From: [Wolfenbarger, Jeanne](#)
To: ["Jeff Wooten"](#); ["Kris Wiest"](#)
Cc: [Michel, Racquel M.](#)
Subject: SEC Gibson/University Cross Access Driveway/Chick-fil-A - TCL Resubmittals ((M15-D012C and M15-D012D)
Date: Friday, April 17, 2015 11:24:09 AM

SEC Gibson at University
Cross Access Driveway
Albuquerque, New Mexico

Traffic Circulation
Layout

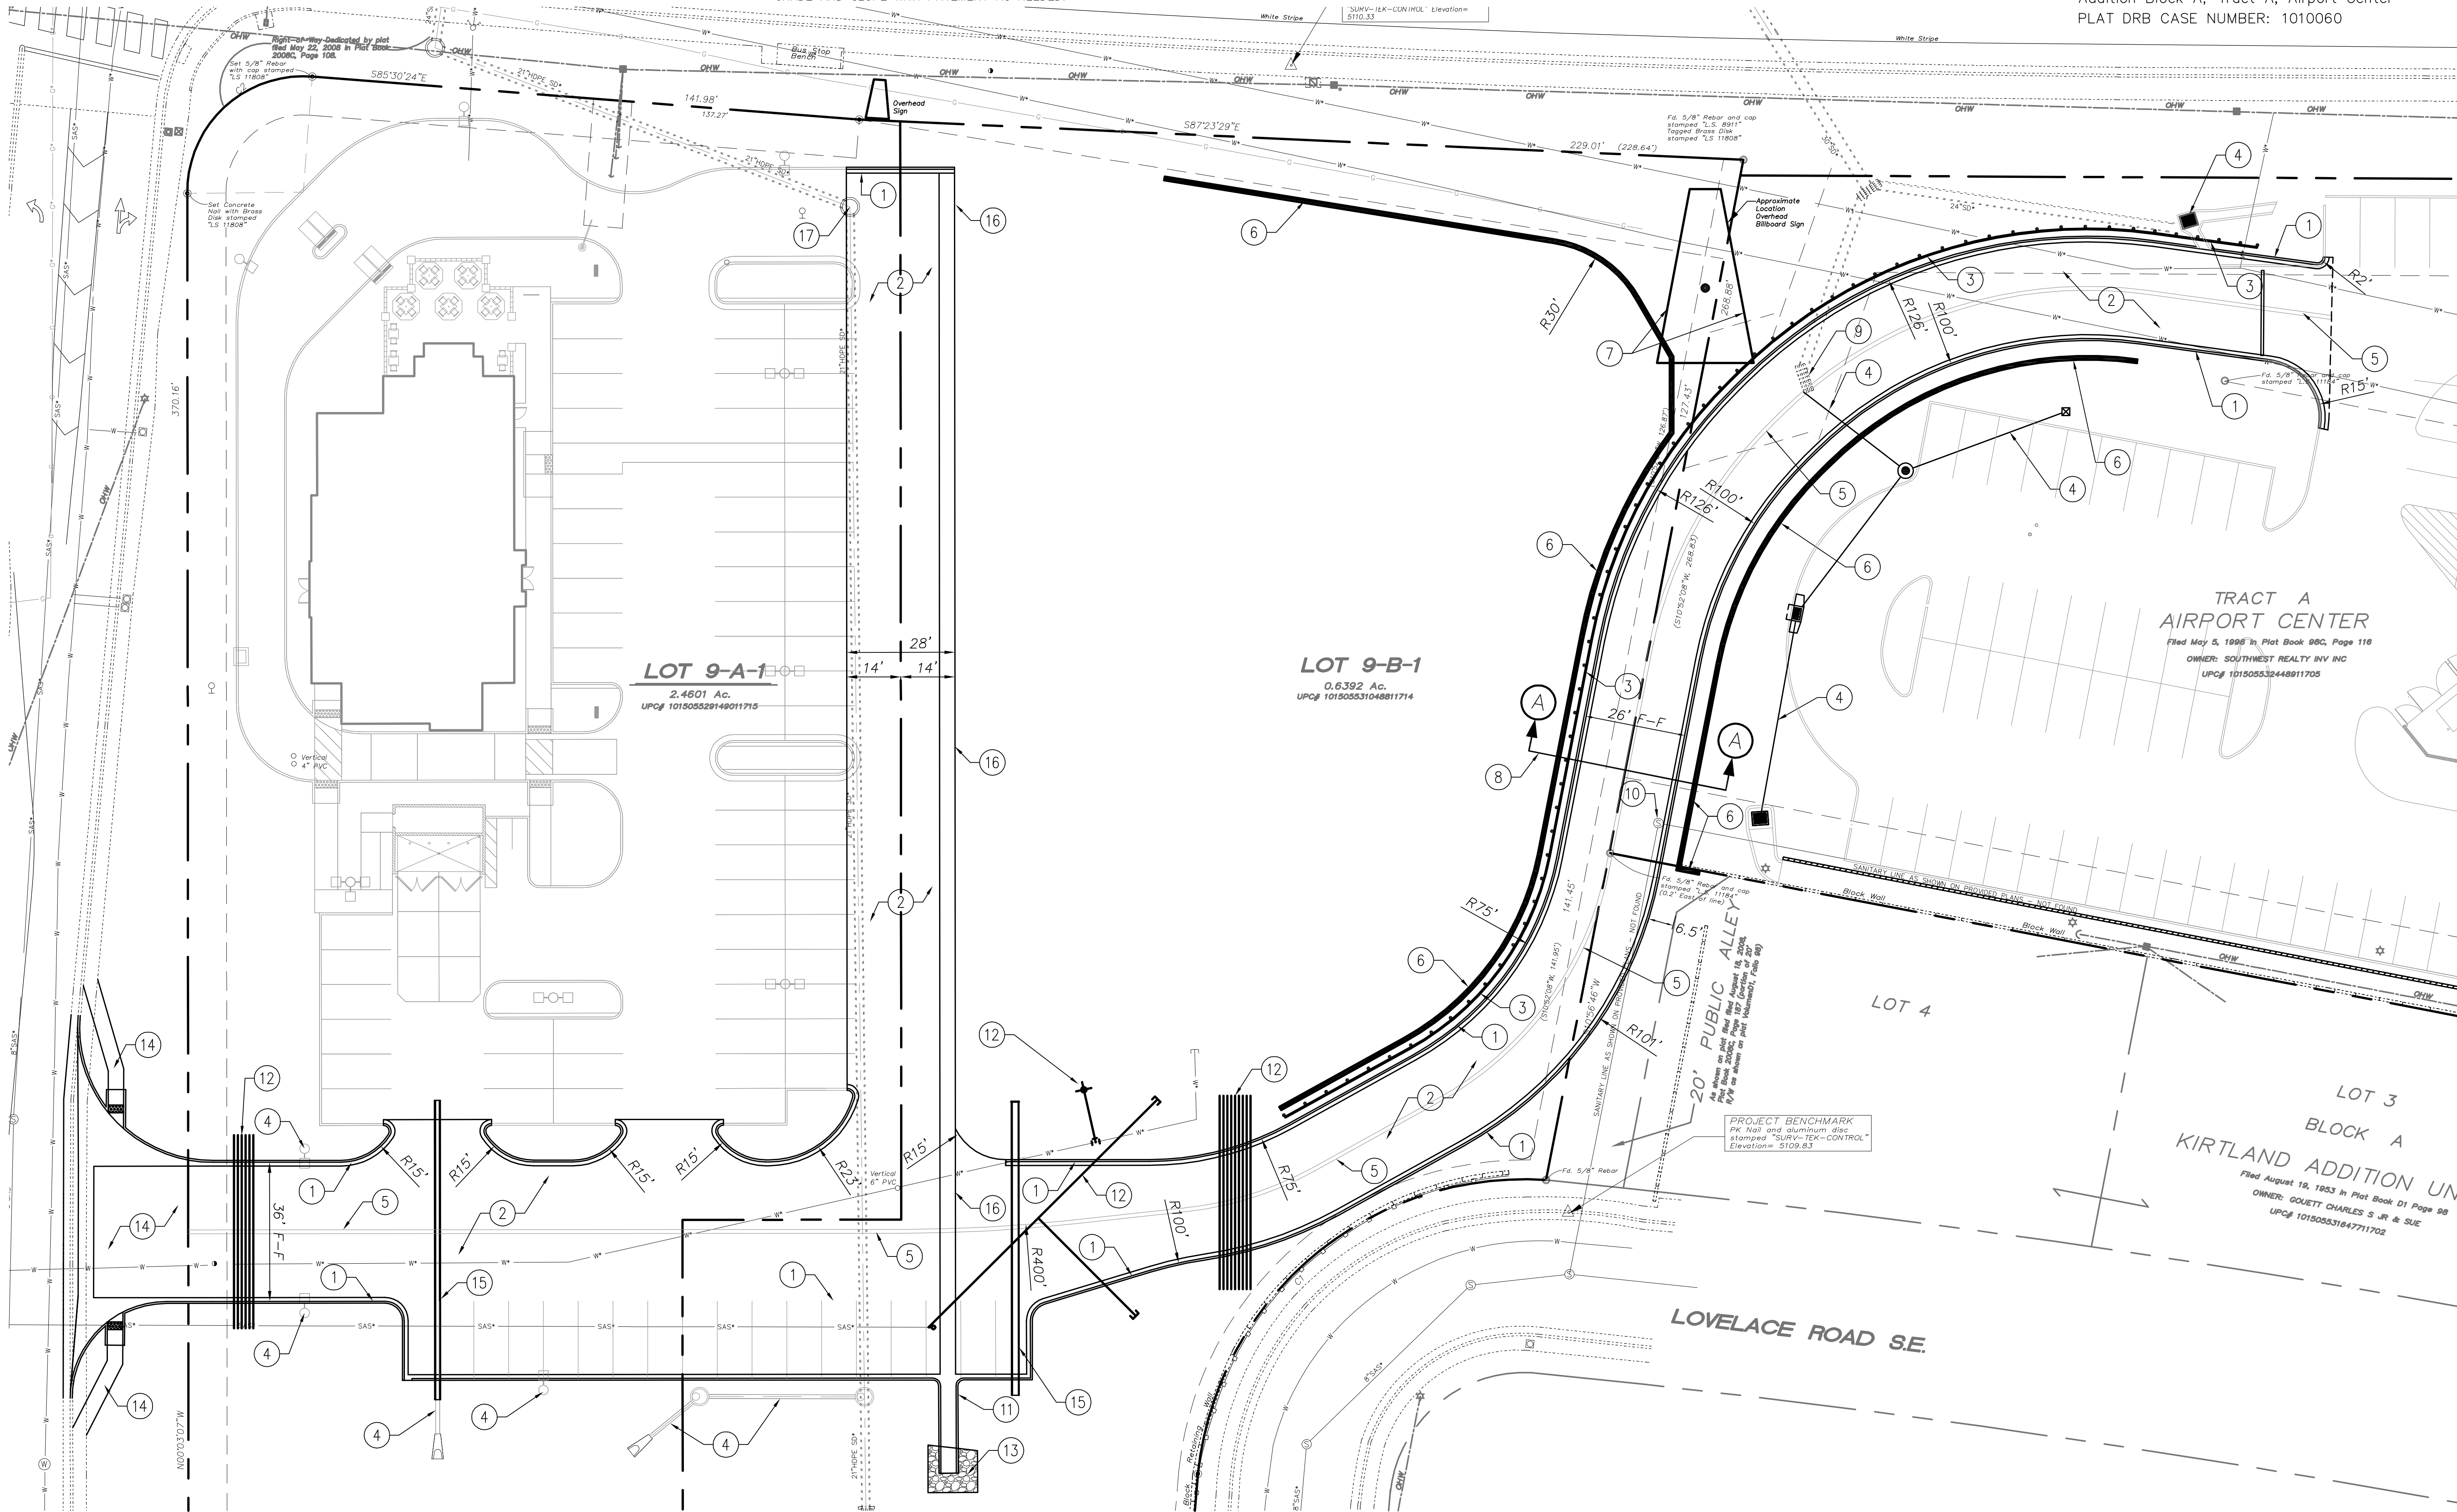
- The pavement section that you show is not an exact match for what is shown on the Merrick planset. (Your plan set calls for 12" subgrade, while the other plan set doesn't. The Merrick set calls out for a 1.5" lift and a 2.5" lift while your detail on Sheet C7 does not contain actual details of lift thicknesses.) This does not affect TCL approval as much as I just wanted to point this out to make sure there is not any confusion during construction with regard to exactly what pavement section to build for your access. If there are different pavement sections being used from one planset to the other, this ought to be reflected on each of the different plan sets.
